Southeast Health Center Expansion

Civic Design Review Phase 3 Submission Package

July 5, 2019

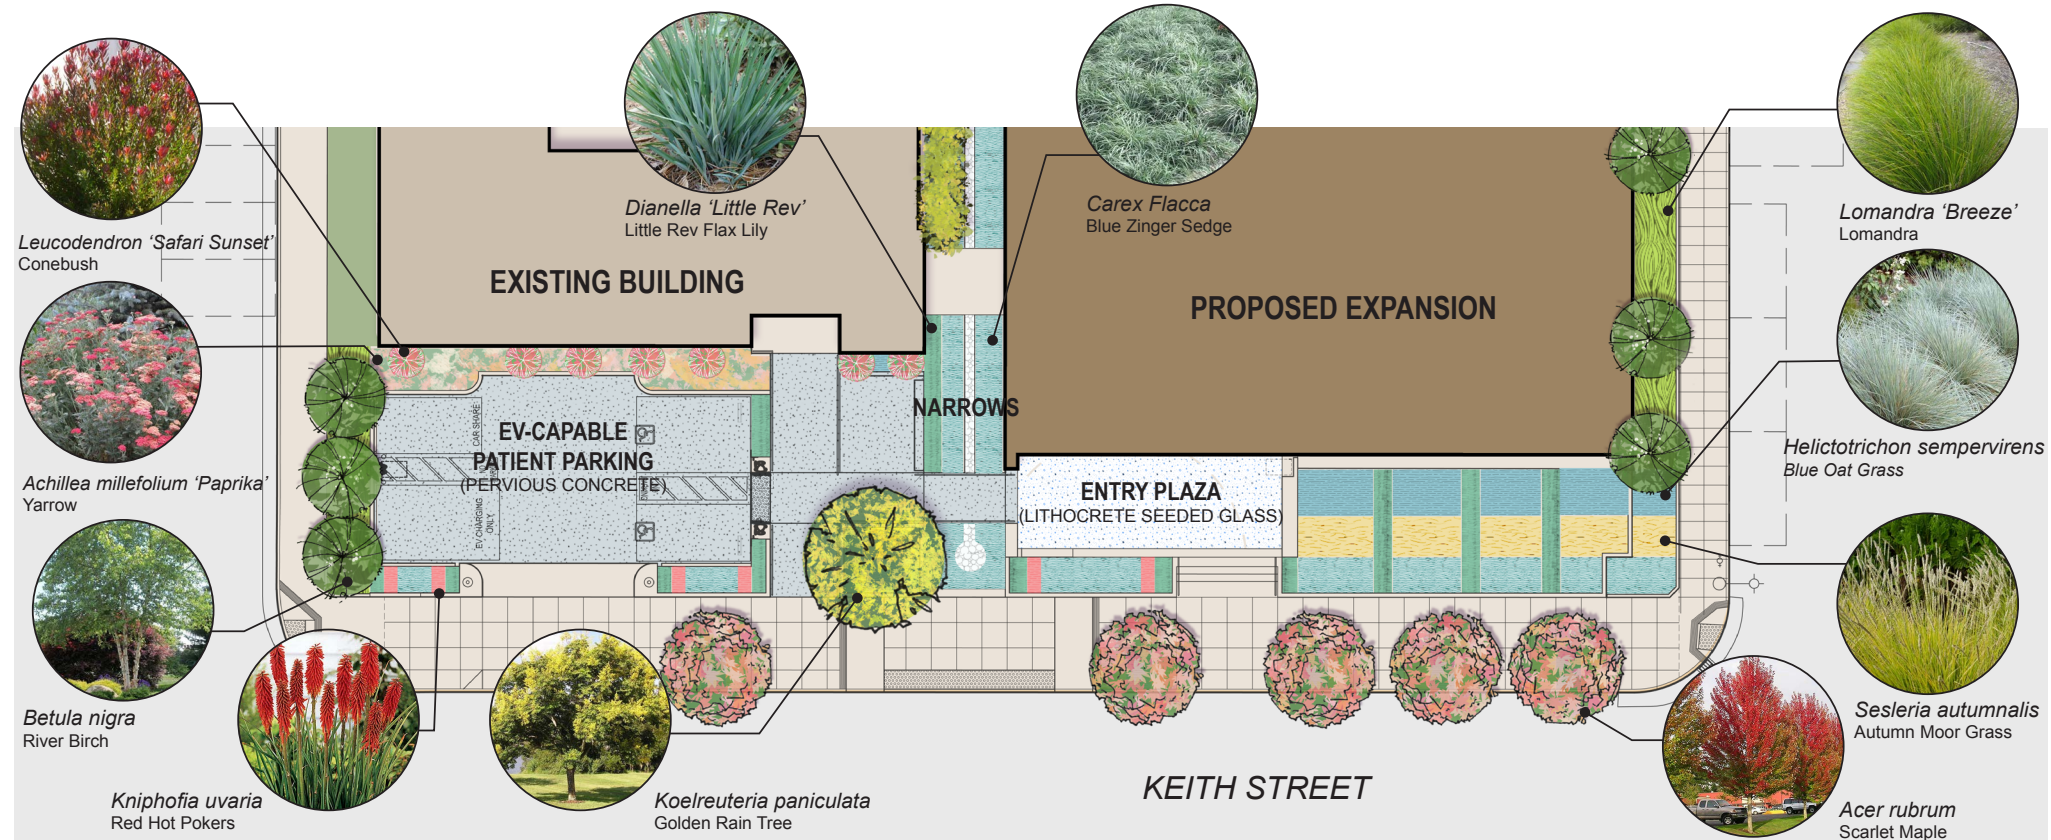
LANDSCAPE: MODIFIED PLANTING PALETTE
